NOTICE TO CONTRACTORS
BID #1516-014

**Carson City Fiber Optic – Dispatch to Public Works and
Community Center to Public Works**
PWP # CC-2015-245

Addendum No. 3

SHEET
C2
OF
31

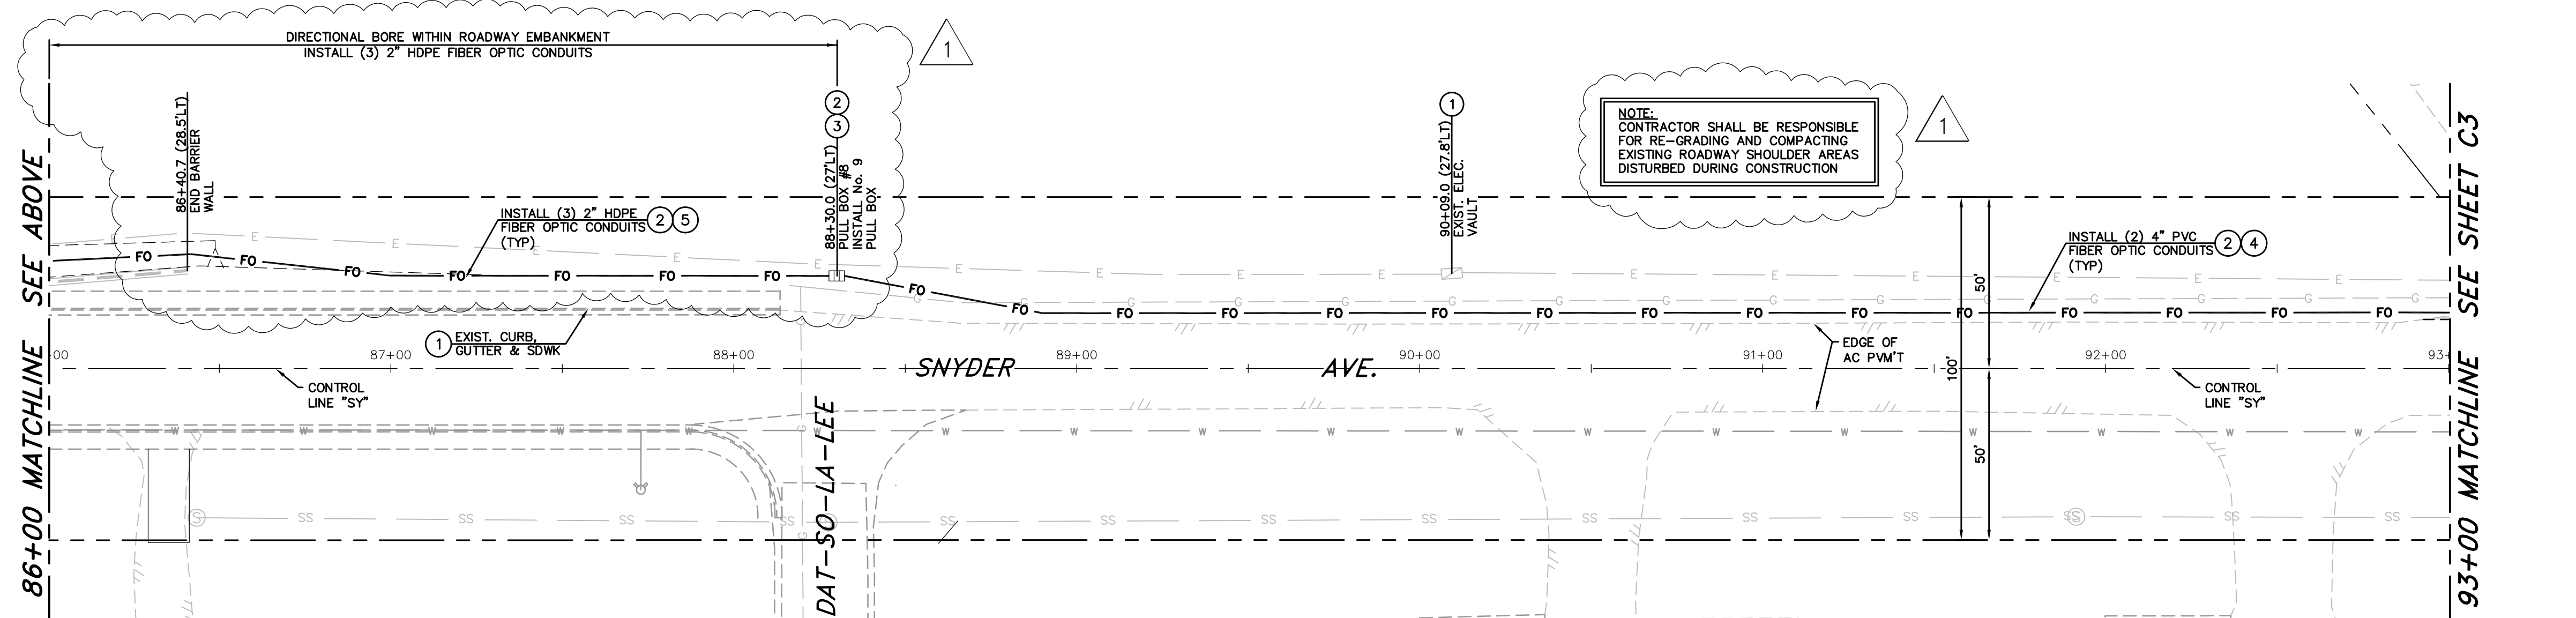
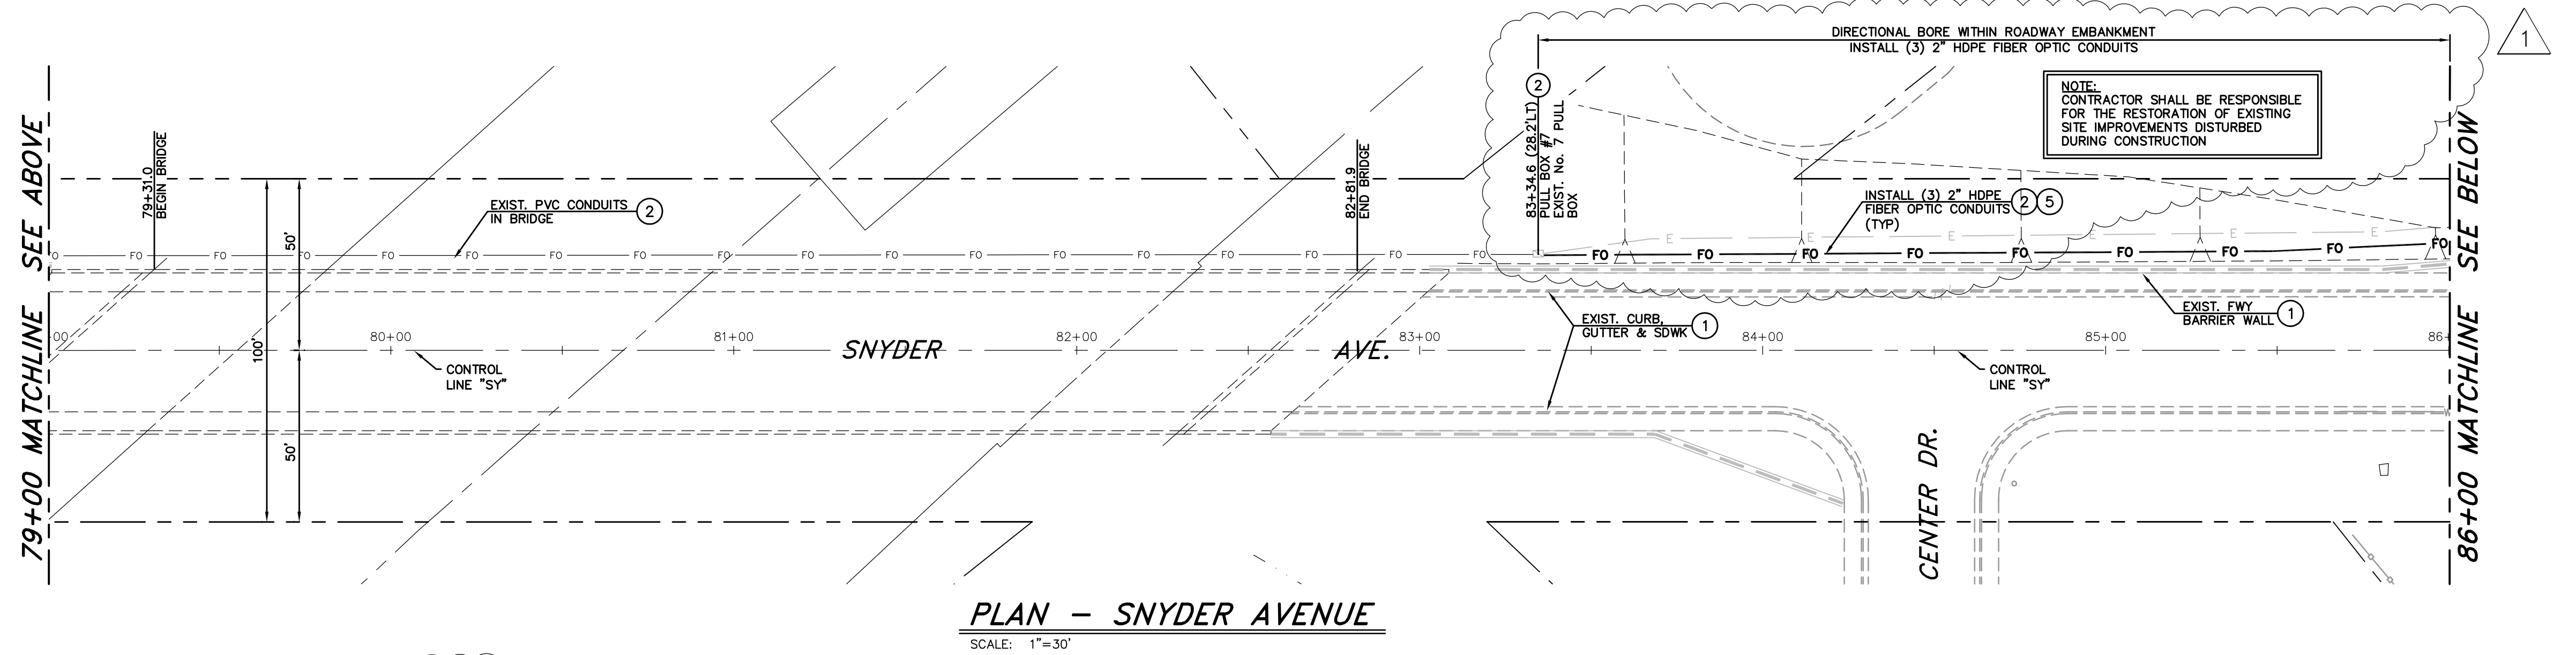
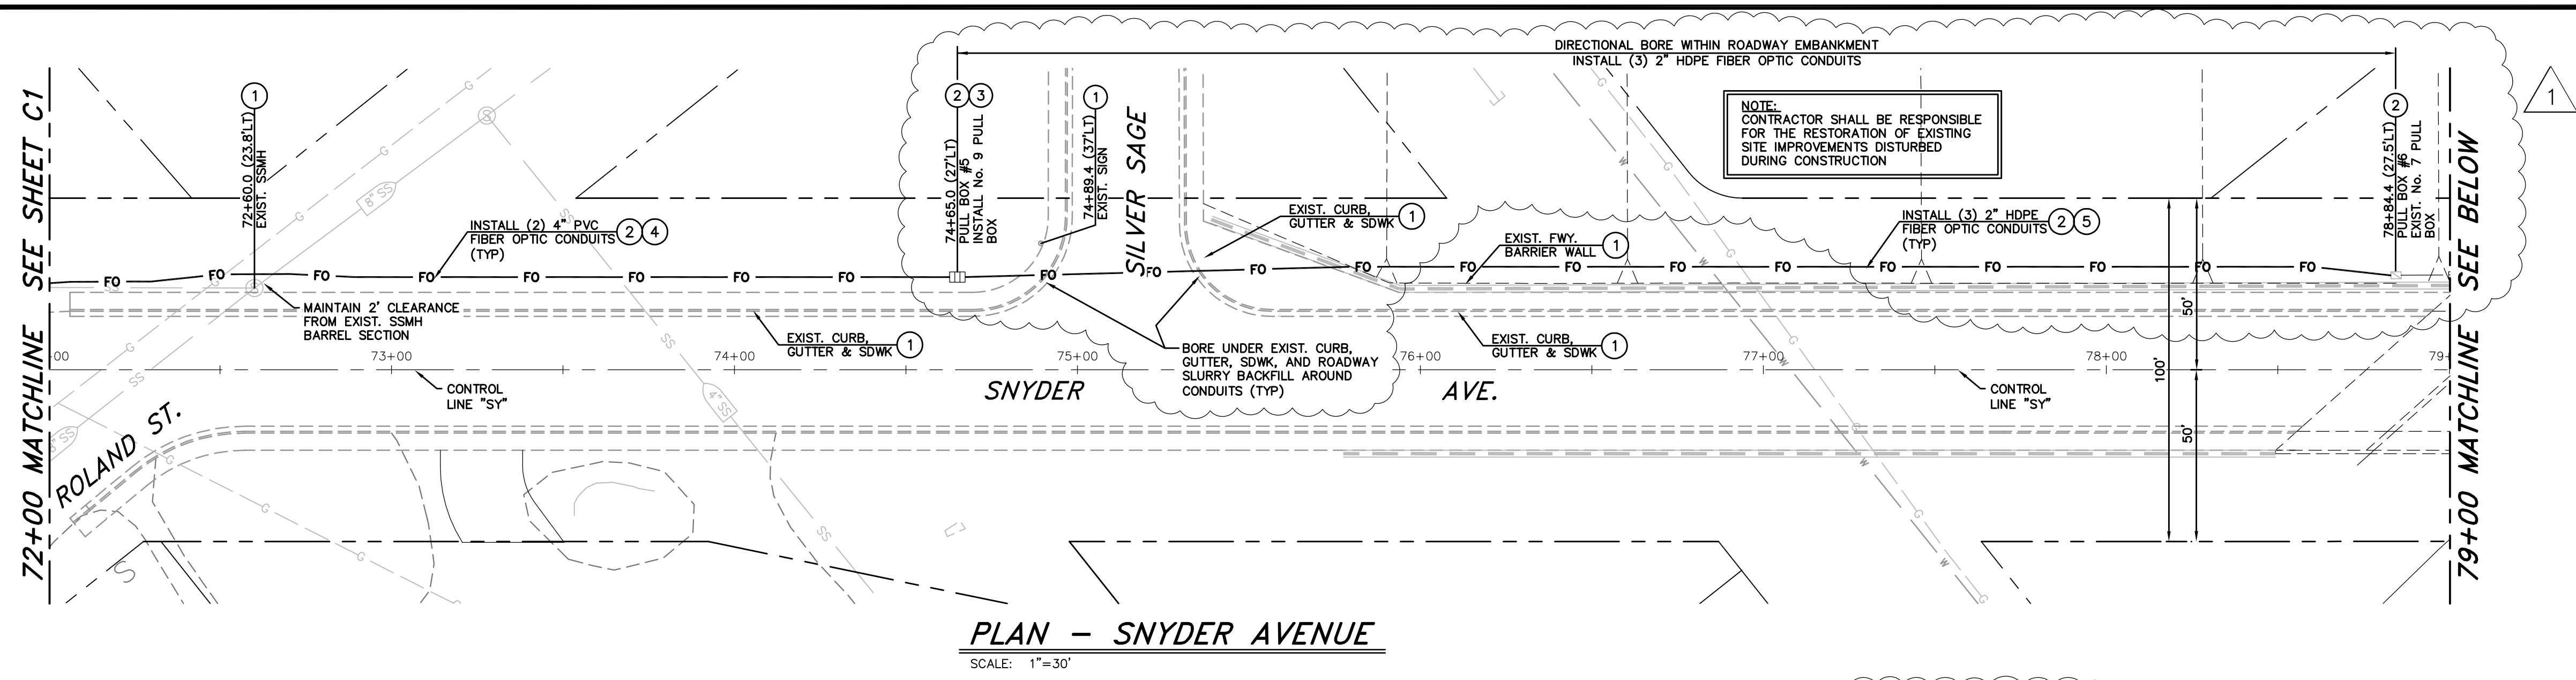
1. A revised sheet C2 is included in this addendum due to changes made around the Snyder Bridge. Please see response to question “4-i” below for additional information.
2. Please use the attached revised bid schedule when completing the bid schedule. The revised bid schedule includes an additional item for boring 3-2” HDPE conduits near the Snyder Bridge as well as adjusting the quantity for 2-4” PVC conduits accordingly.
3. The bid item description for the 3-2” HDPE conduits is as follows:

- i. At the new highway over pass I found a no. 7 box at each end of the bridge with 3 - 2" conduits. The box is at the top of the bridge and there is no shoulder to dig along the back side of the concrete barrier. Is there a stub or do we have to dig down the bank?

The Contractor will be required to bore from station 74+85 to 78+84 and 83+34 to 88+30 along Snyder Avenue with 3-2" hdpe conduits. These two conduit runs are just prior to and after the Snyder overpass where there are 3-2" existing conduits. Pull box number 5 is to be installed at station 74+85 at the start of the bore rather than 75+59.5 as shown on the plans. Pull box number 8 has been moved to station 88+30 from station 88+20 to give added space from the existing gas line.
